ADDENDUM

Forestside Estates
Attmar & Palleschi Drive
Brampton, Ontario
Attn: **Vince Staffieri**

AM 08

PROJECT	**: Forestside**
PROJECT #	**: 1331.15**
DATE	**: Jan 18, 2021**

GROUND FLOOR OVERALL PLAN

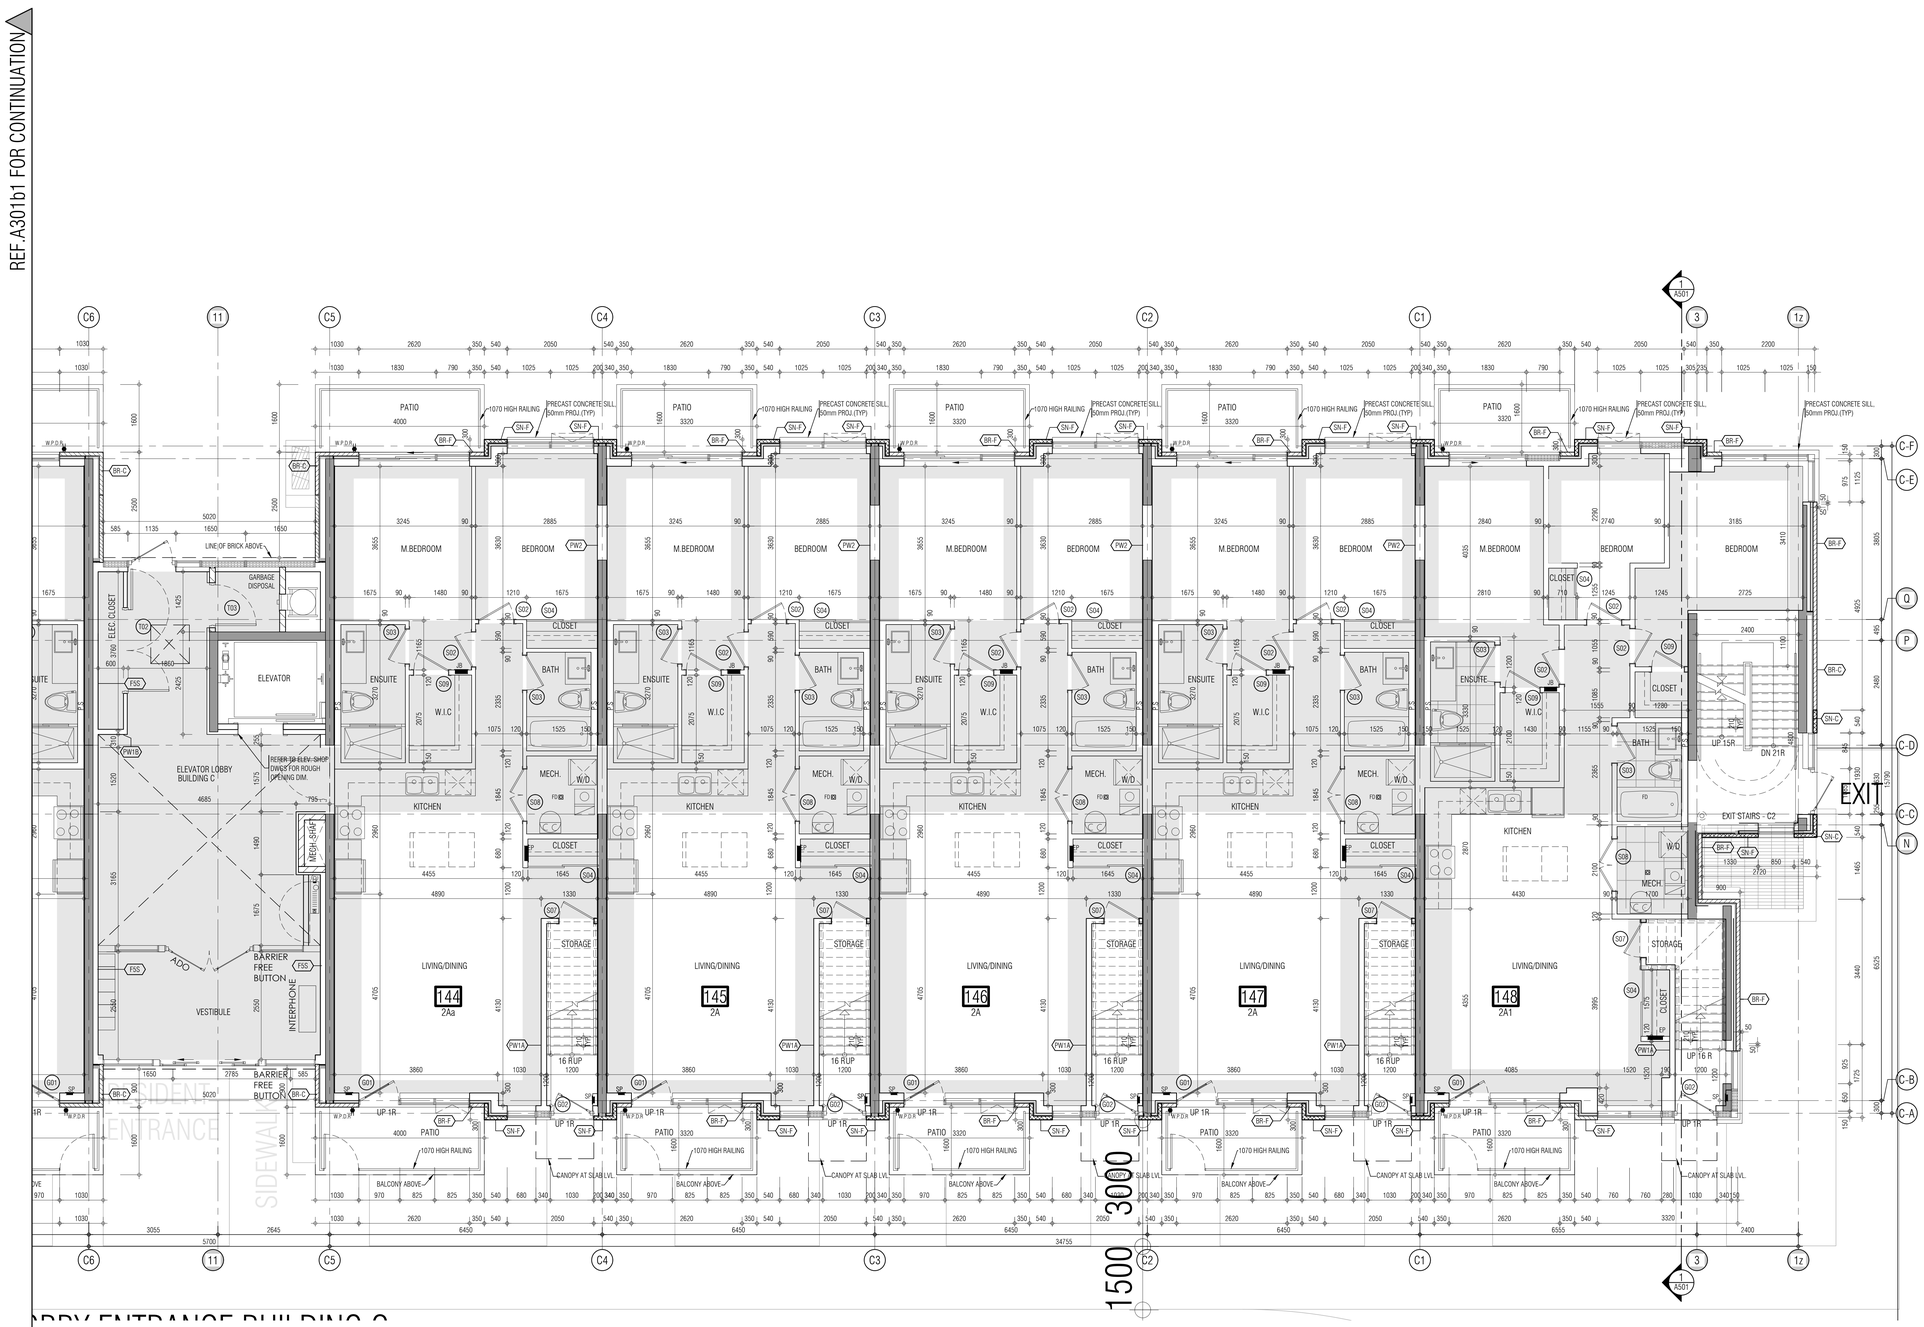
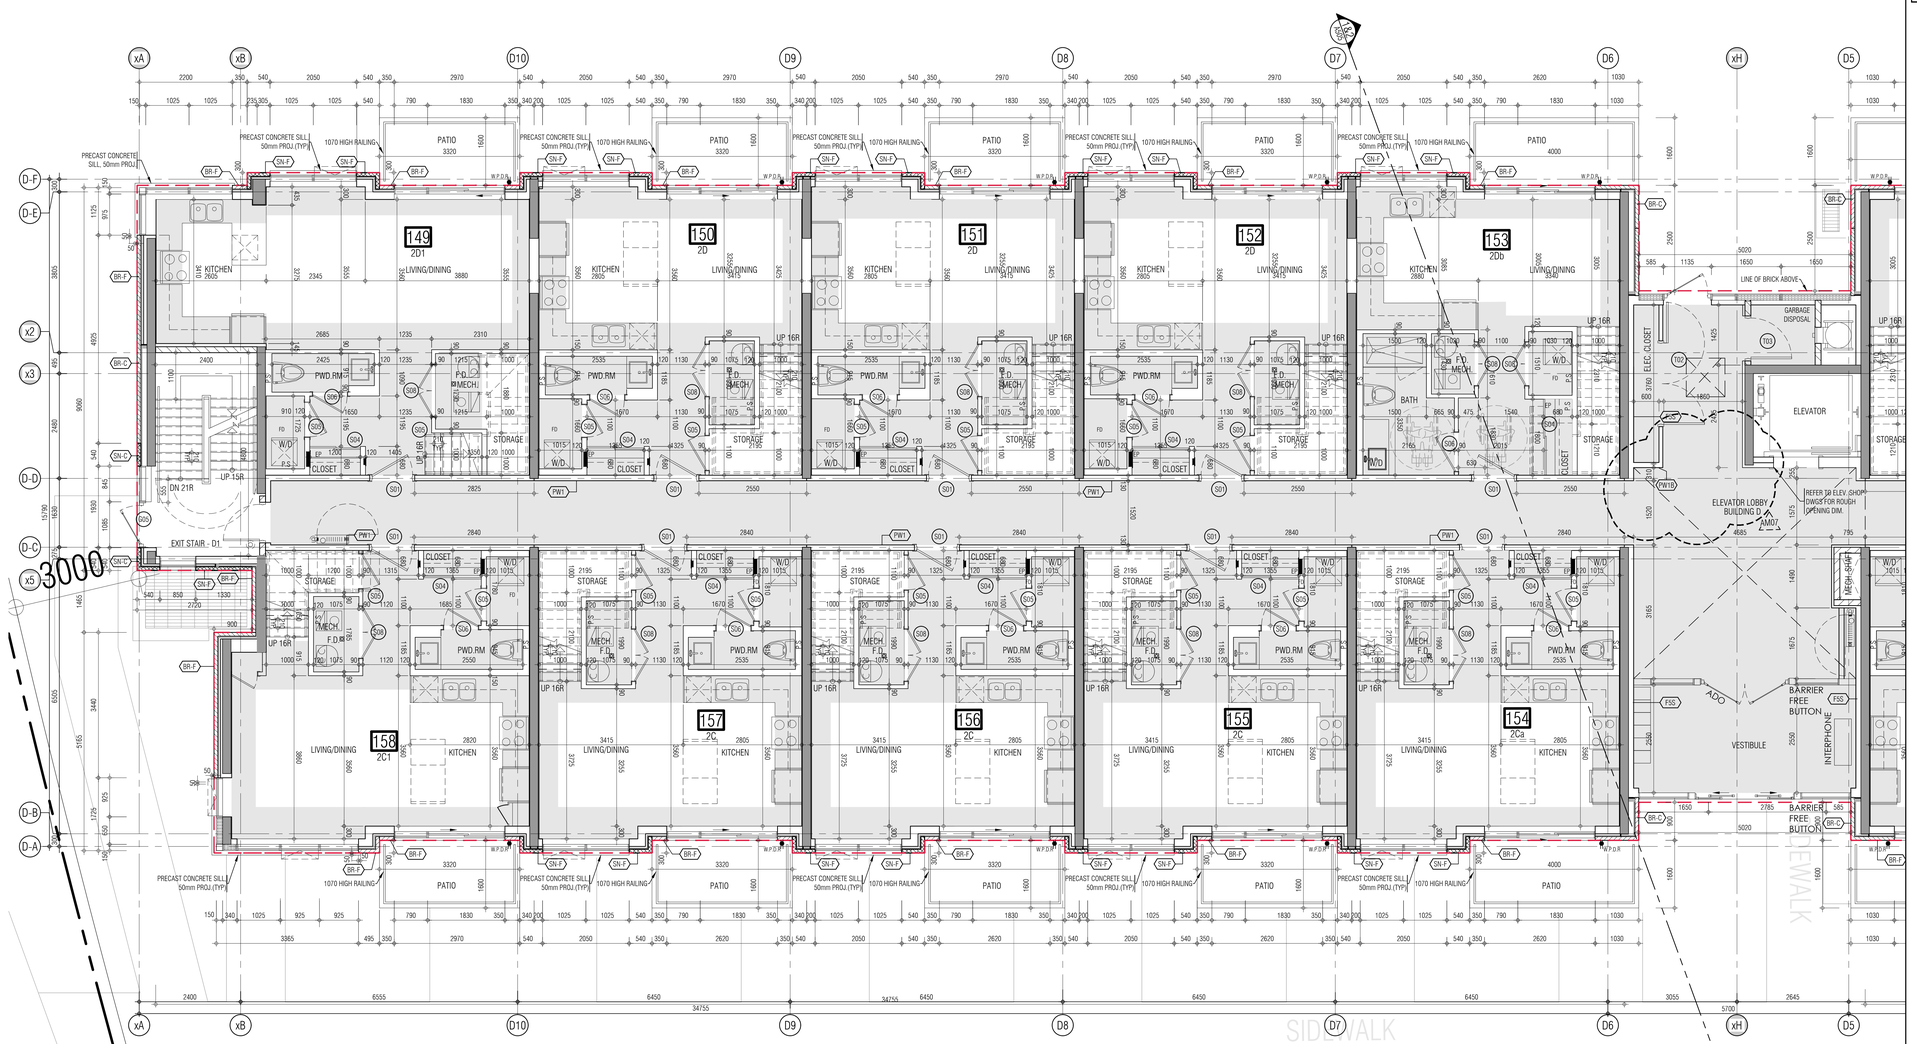
A301-A304	1st – 4th Floor Plans	• Move Blocks A and B north 286mm to comply with 0.3m easement and 3.0m minimum set back to property line as per clients request. • Move Block D up 390mm along angle north to comply with 0.3m easement and 3.0m minimum set back to property line as per clients request.
A701a-A701b	Stair Sections	• Revised dimensions on stair plans to match blocks that were moved.

Reason: **Move Blocks north to comply with 0.3m reserve and meet the 3.0m minimum setback to the property line as directed by client.**
